Platform A1 - Booth area  
Previous comments are  
still valid, see following  
slides

Platform A1 – Oven area

Axes 5/012

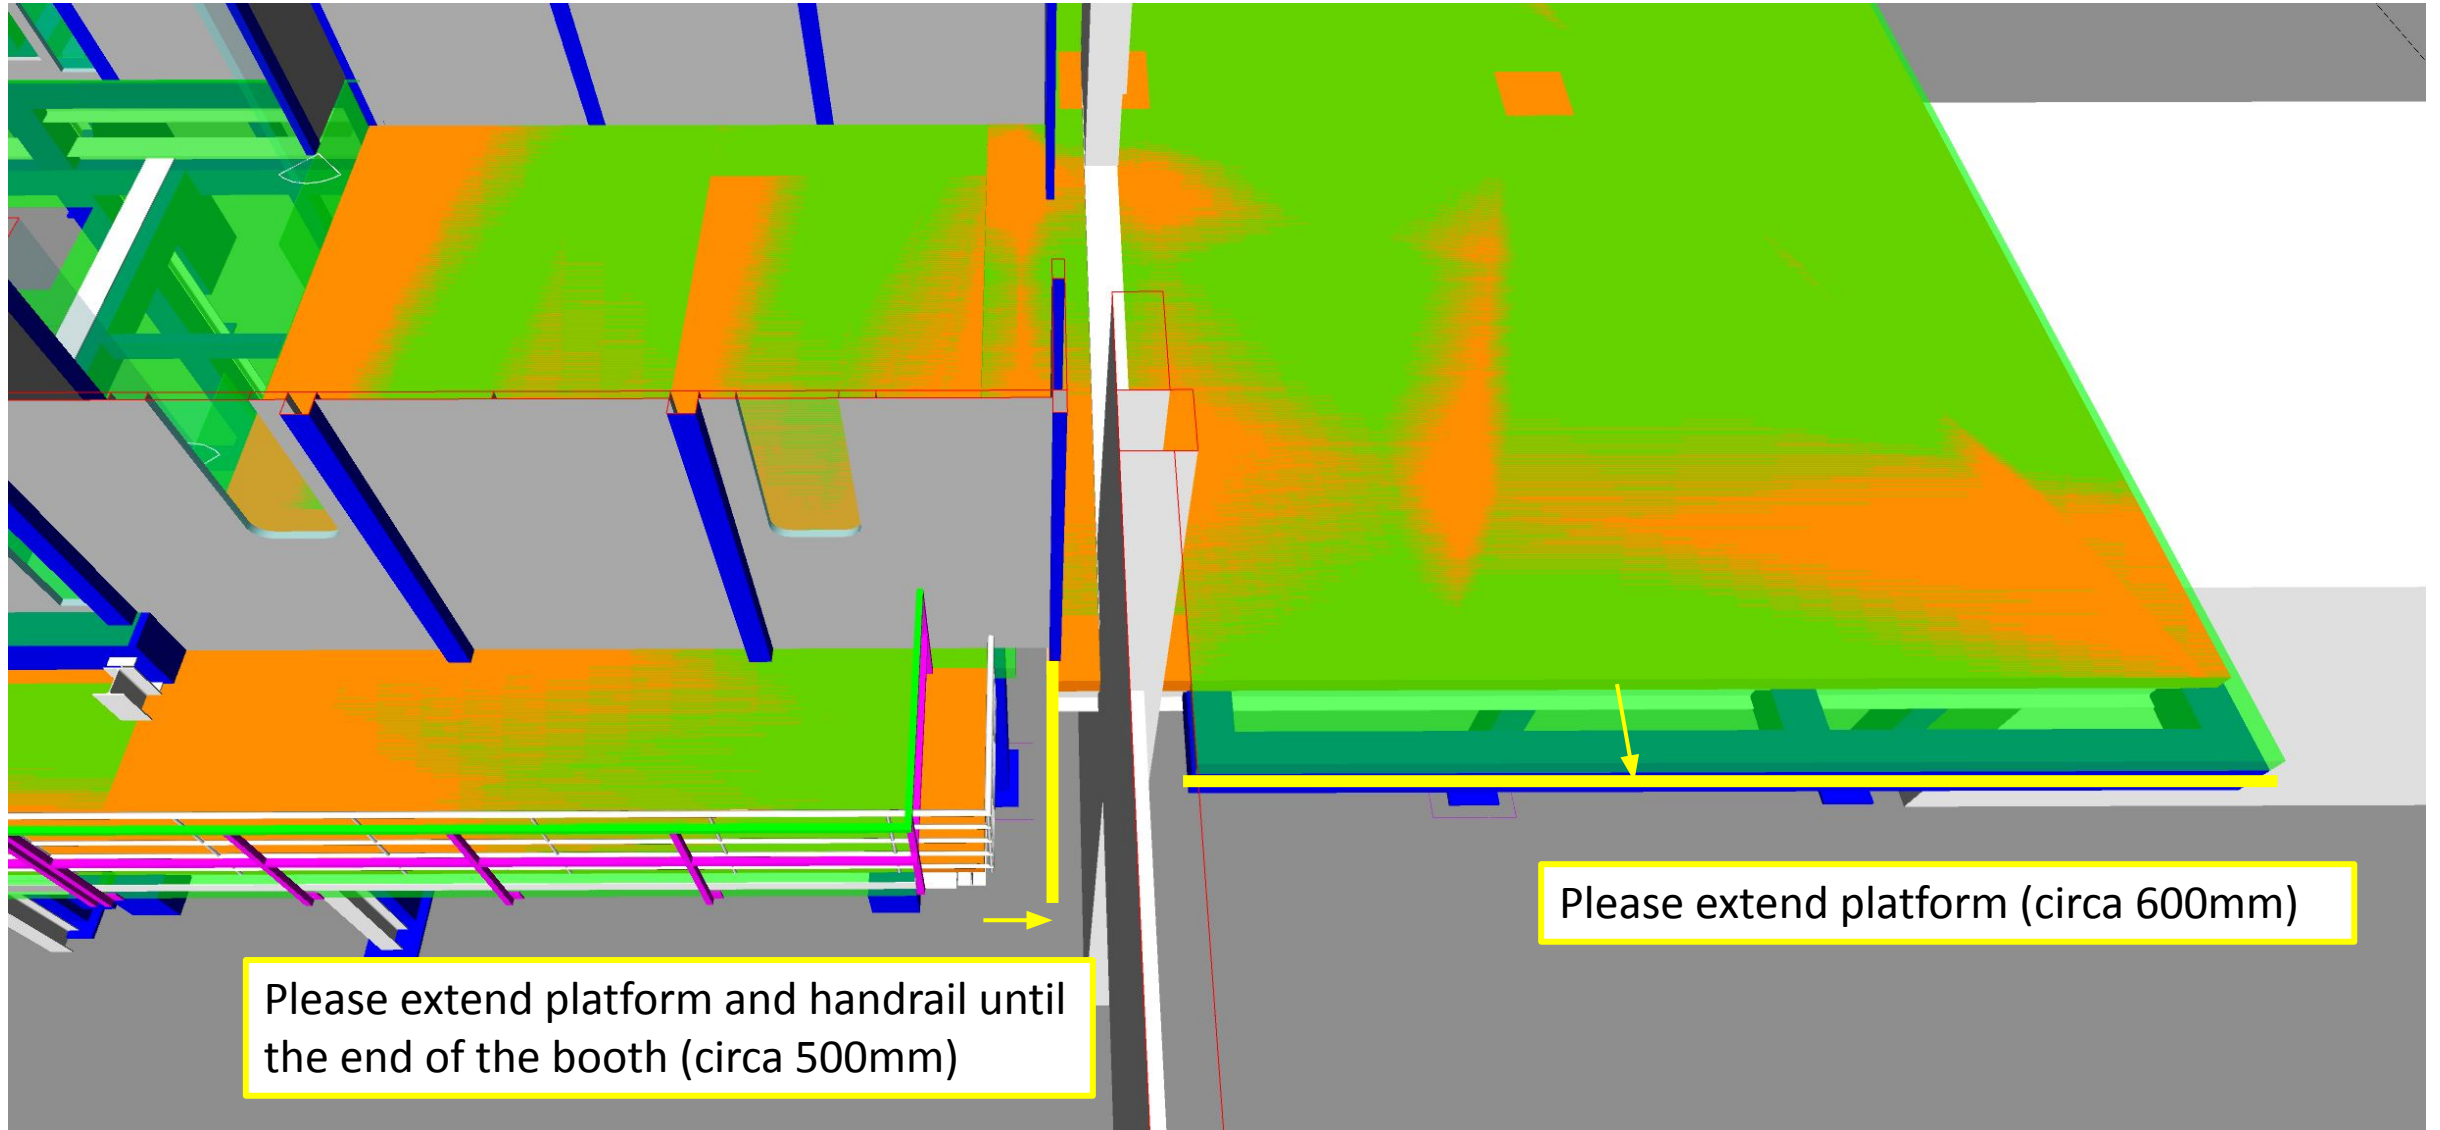
Be sure to respect Oven perimeter when modeling walkable modules around it

Axes 8/012

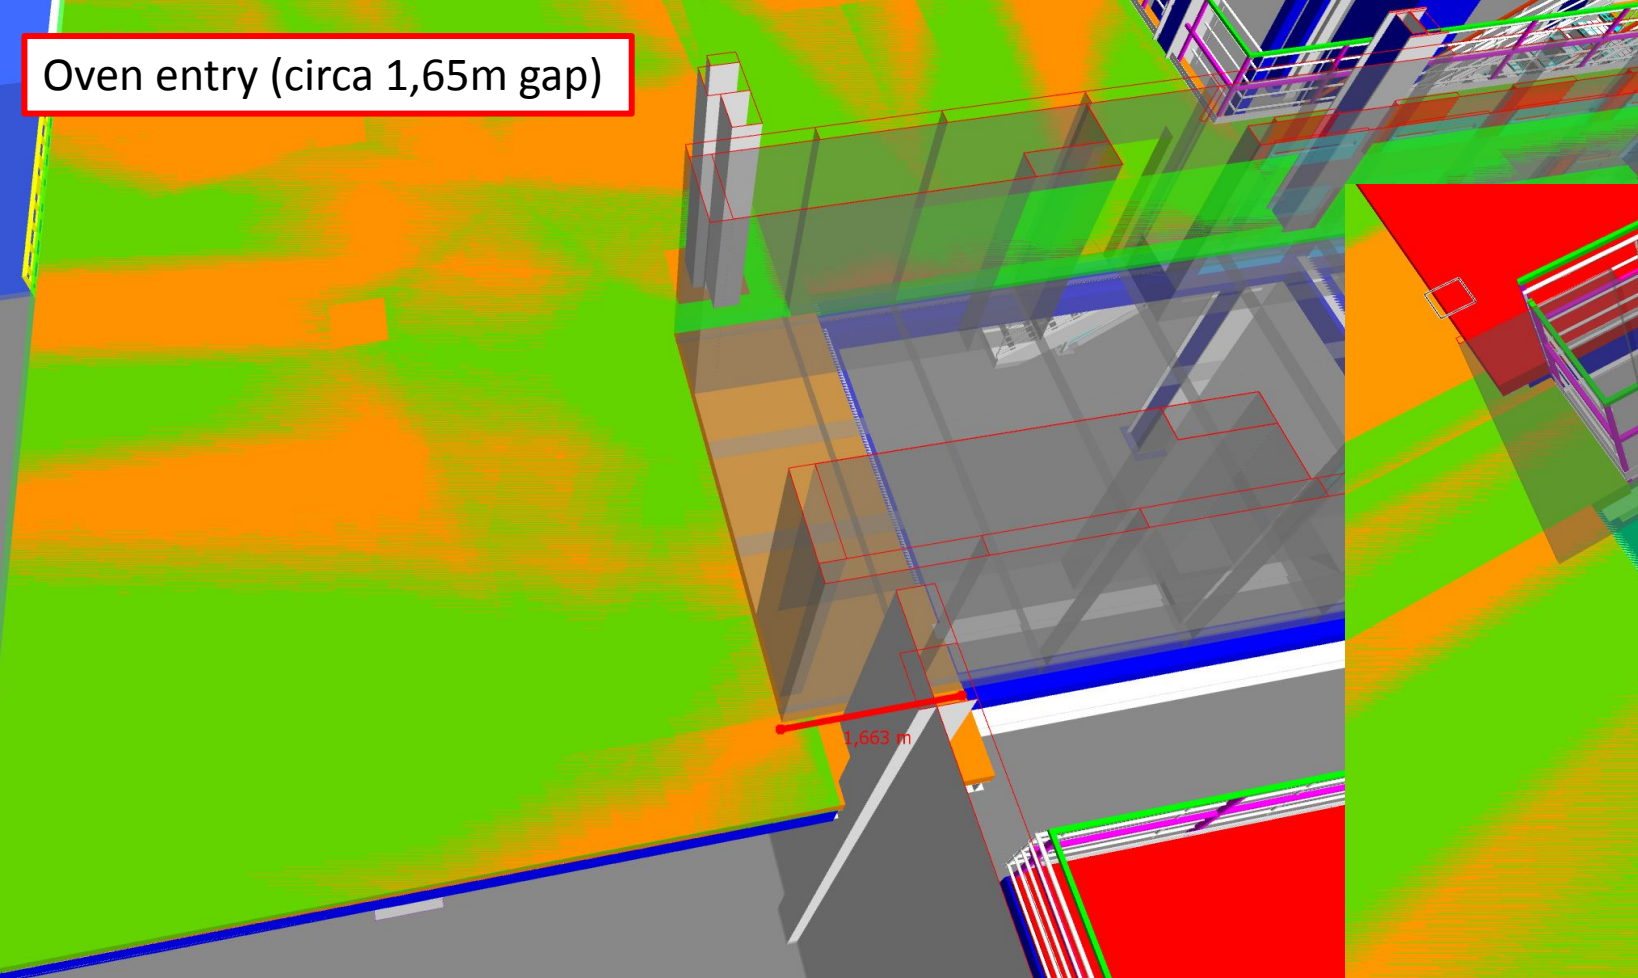
Oven entry (circa 1,65m gap)

Oven exit (circa 730mm gap)

## Platform A1 – Oven area

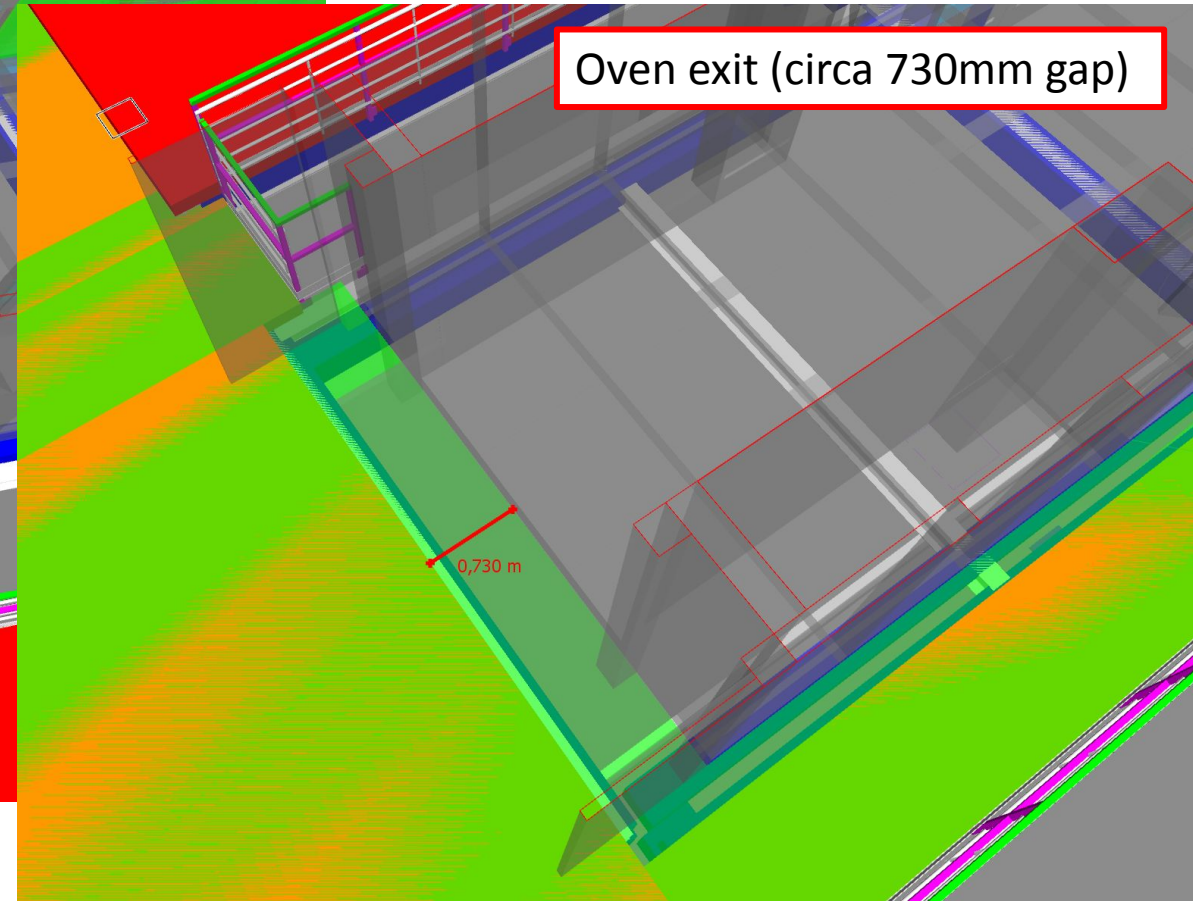
Oven center axis is positioned 3m west of axis 8

Axes 7-8/013

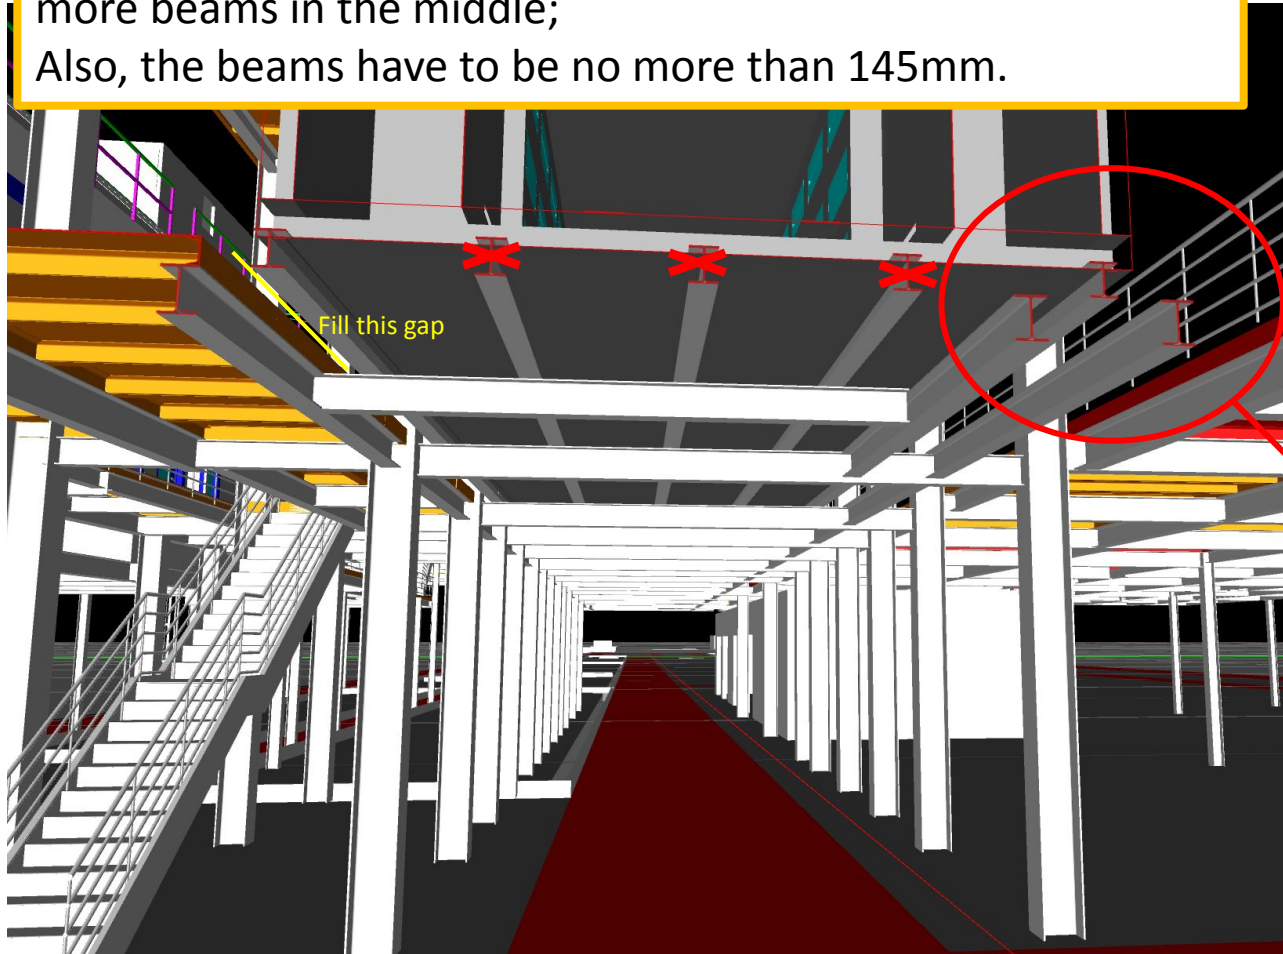
Update (08/06): the Oven load is only transferred to the two longitudinal beams on each side, there's no need to put more beams in the middle;  
Also, the beams have to be no more than 145mm.

Axes 7-8/012-019

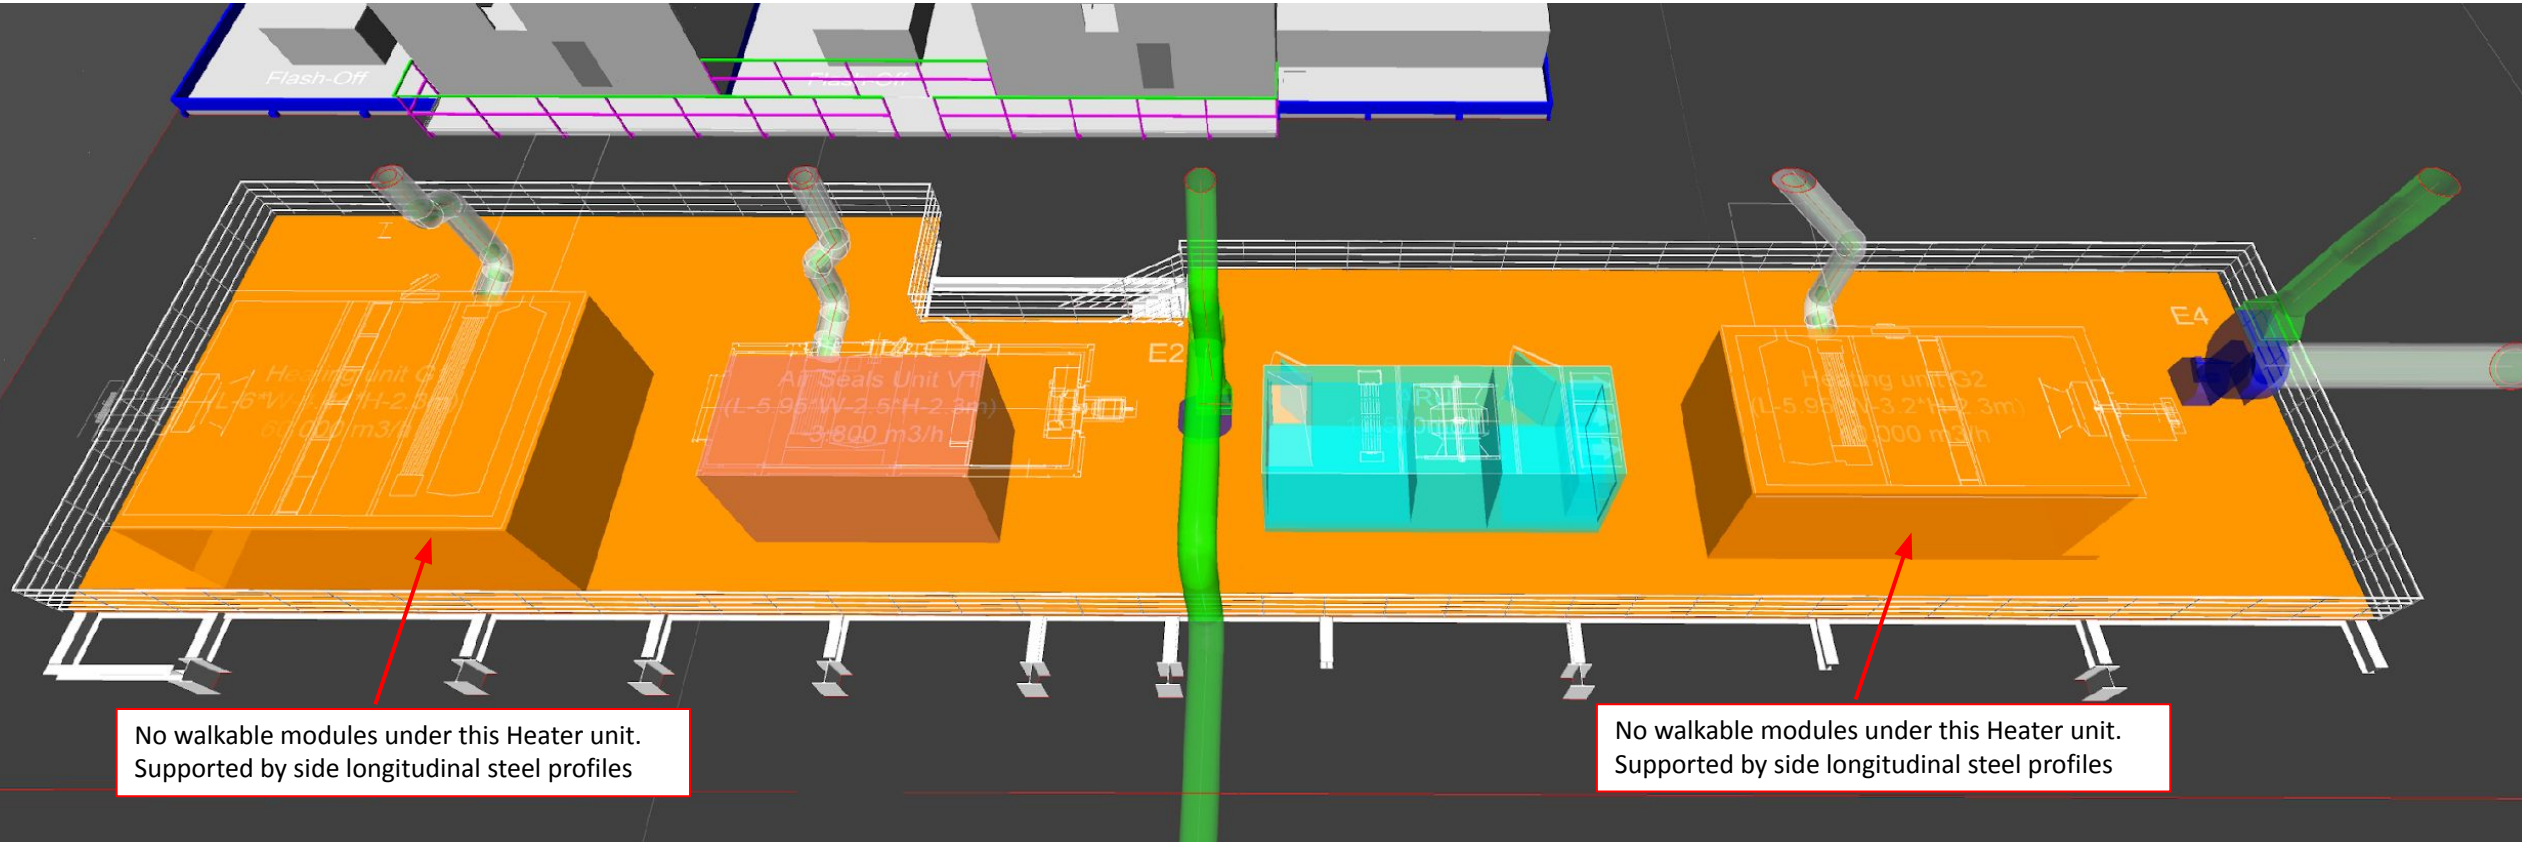
Keep in mind that we have ducts penetrating platforms under the two Heater groups, these ducts will have insulation (150mm all around).  
I will submit information about these duct location in order to avoid clash with supporting beams

Platform A2 – Demasking & IRC area (axes 8-10/013-015):

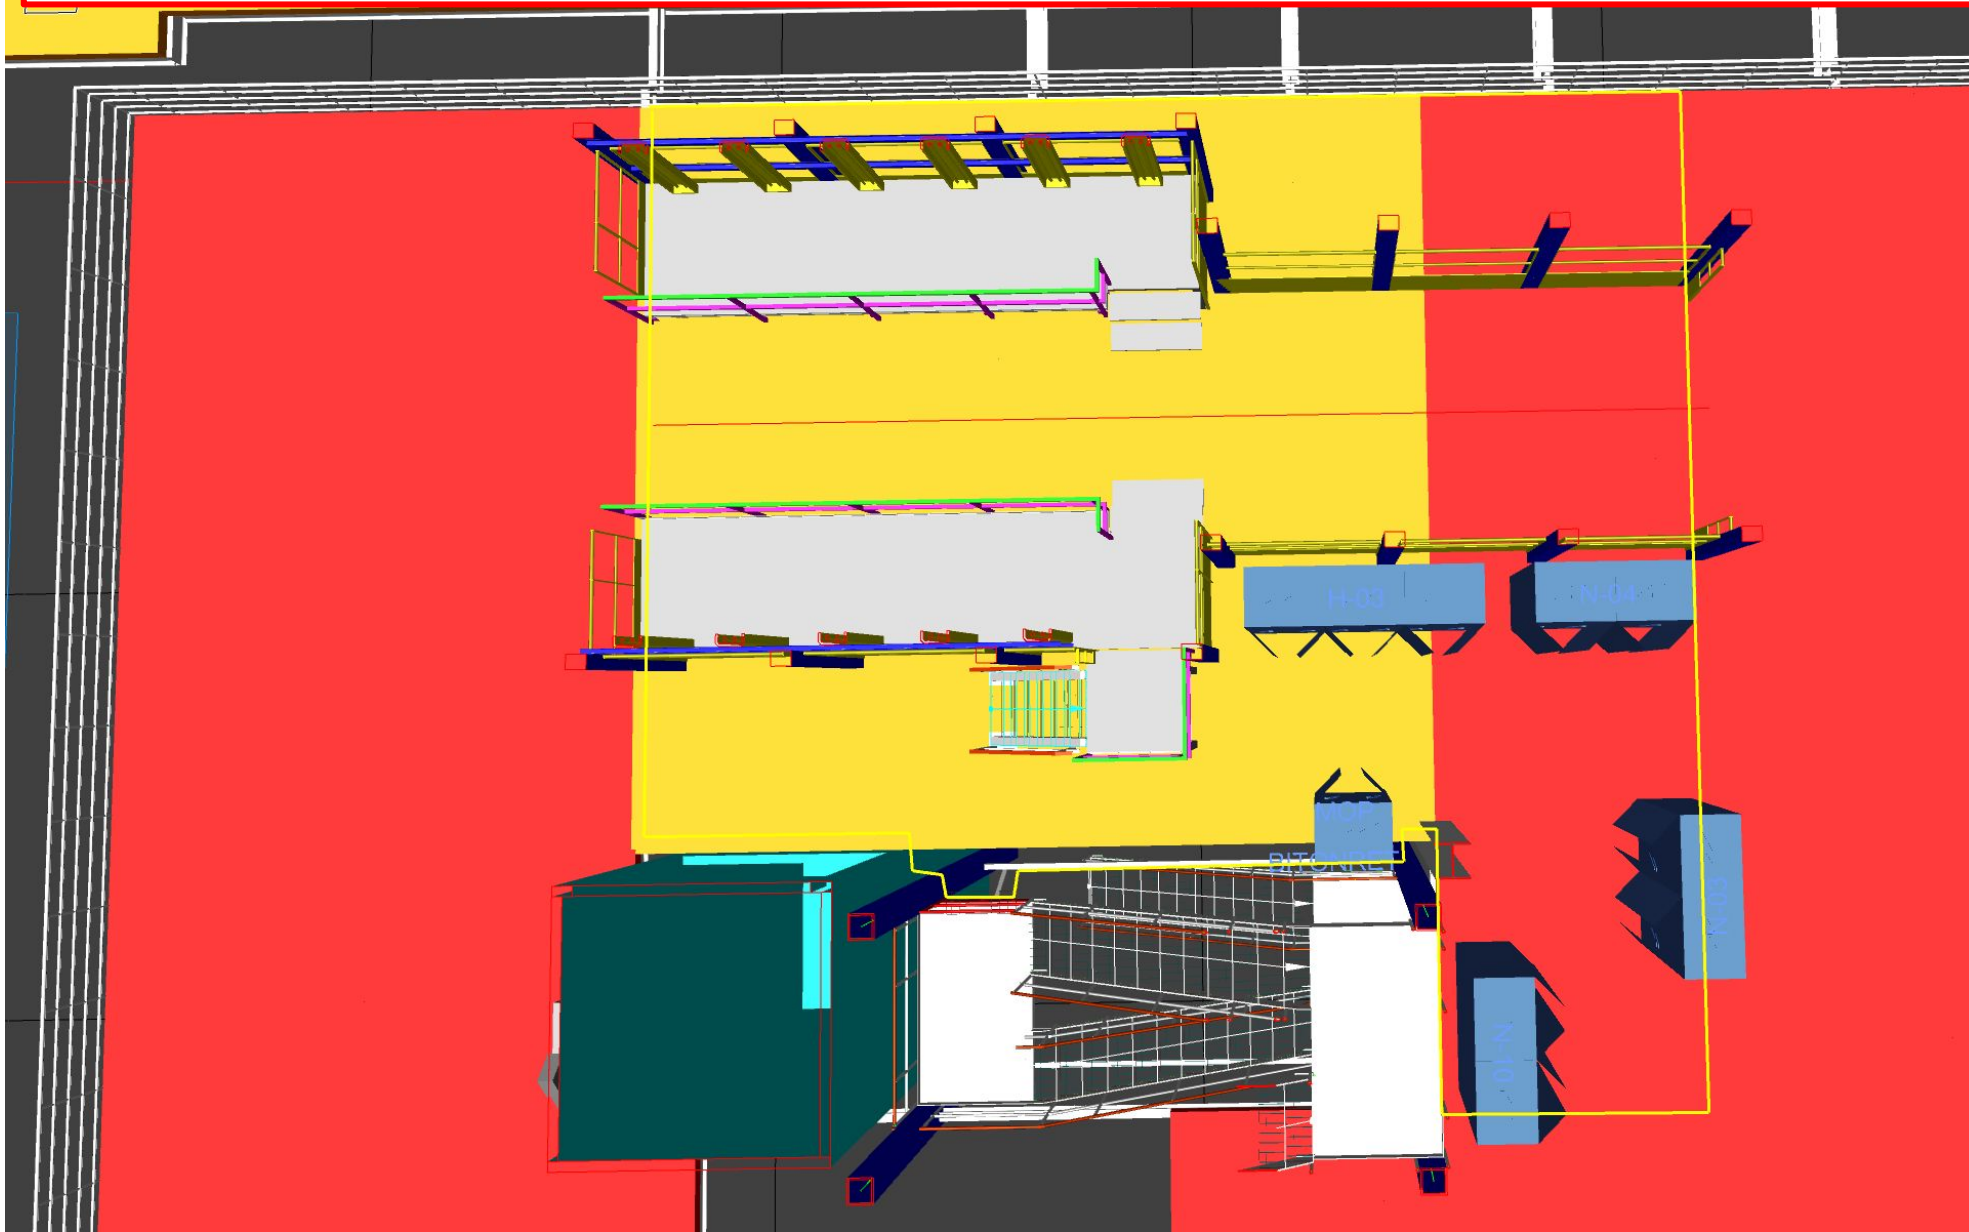
The area to be covered with walkable modules shall be the one circled in Yellow, basically under the two open Booths and under Electrical cabinets, as shown on General Layout uploaded in drive on 04 April (rev E – in progress)

Update:  
Comment still valid
